CITY OF SACRAMENTO
1231 I Street, Sacramento, CA 95814

Permit No: 0009856
Insp Area: 2

Nature of Work: REROOF T/O 46SQ PIONEER TILE

Subject: Structural Investigation Report of the Roof for the Residence located at 779 Skylake Way, Sacramento, CA 95831.

ROOF PLAN - HING

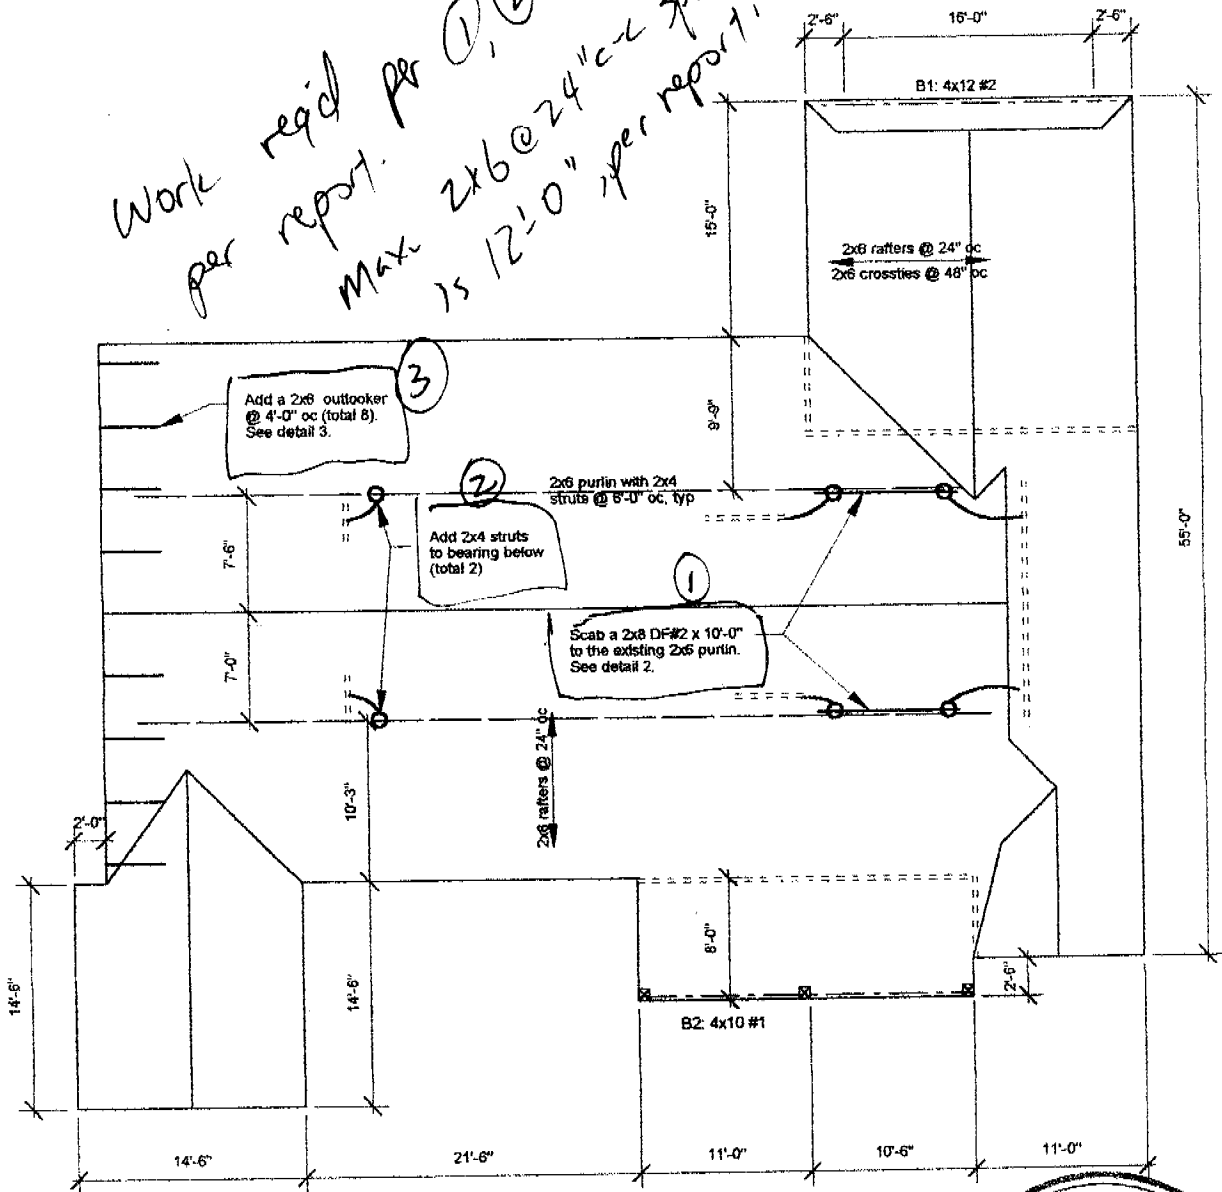
Work req'd per ①, ② & ③
 per report.
 Max 2x6 @ 24" oc span
 is 12'-0" per report.
